# PULTE 2 DEGREES

DESIGN RECOMMENDATION | SDCI #3036032-LU | 13 JUNE 2022

ADDRESS: 12201 STONE AVE N | SEATTLE, WA 98133

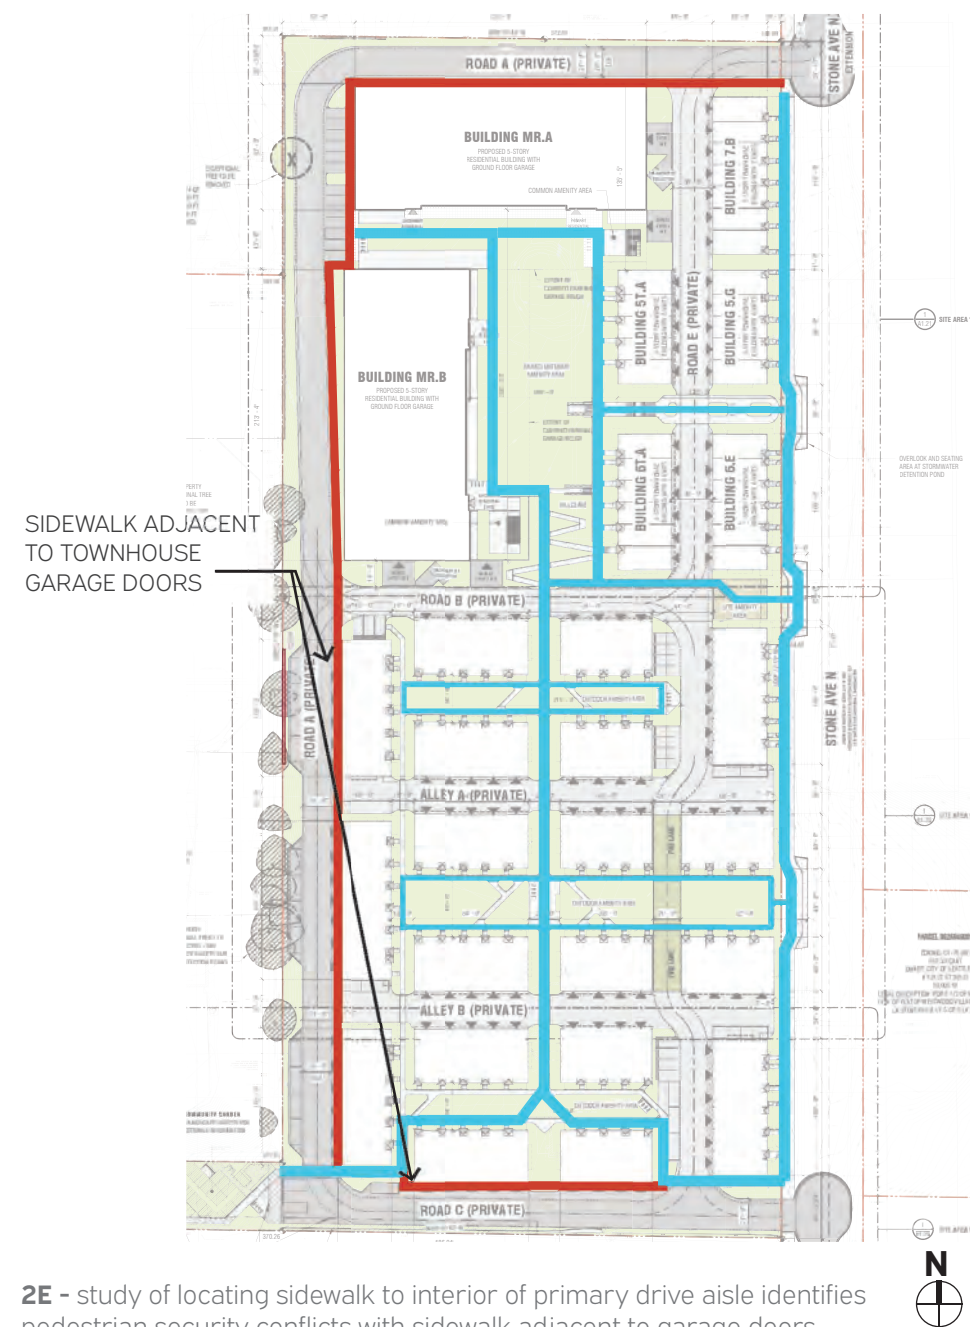
- C. The Board expressed concern regarding the blank wall condition (created by the parking level) at the southwest corner of the open space and agreed that the composition of this area should include uses or design treatments at the street level that have human scale and are designed for pedestrians. (DC1, DC2-B2, PL2)
- D. The Board strongly supported the character and articulation of design elements shown in the Hill Climb precedent images (p. 50) and agreed that a successful design would require a similar level of care and rigor in the planning and composition of elements. (DC1, CS1, PL2, DC3)

In the proposed design, the exposed area of blank wall at the garage level adjacent to the central hill climb is mitigated with several design strategies. To add visual interest to the concrete structure, the wall will have dense climbing vine plantings and an open guardrail (DC2-B2). The grade at the garage wall is raised slightly, in concert with the ramp and stairs that slope upward toward the raised courtyard, which partly buries the blank wall. In addition, planting areas are proposed directly adjacent and on to the wall, with tall, dense planting to screen the wall and blend the parking garage mass with the overall design of the hill climb.

To create a safe and comfortable walking environment up to the elevated courtyard, a wide, thoughtfully designed ADA compliant pedestrian ramp and integrated stair is proposed to connect the elevated courtyard to the central spine. Our design proposal uses a variety of landscape elements along the blank walls and inclusion of spaced-out planting areas between each switchback to soften the hardscape elements. Visibility towards neighboring townhouses also provides 'eyes on the street' for this critical juncture, while pedestrian-scale lighting provides increased visibility while being used as wayfinding up and down the hill climb. (PL2, DC1).

The addition of the "Crow's Nest" amenity structure on top of the garage plinth provides opportunity for all-weather pedestrian activation and provides a visual landmark throughout the site. It has been carefully integrated to become part of the hill climb's composition of elements through the use of dynamic roof forms and structure, and angled orientation that mimic the angles of the pedestrian ramps (DC3).
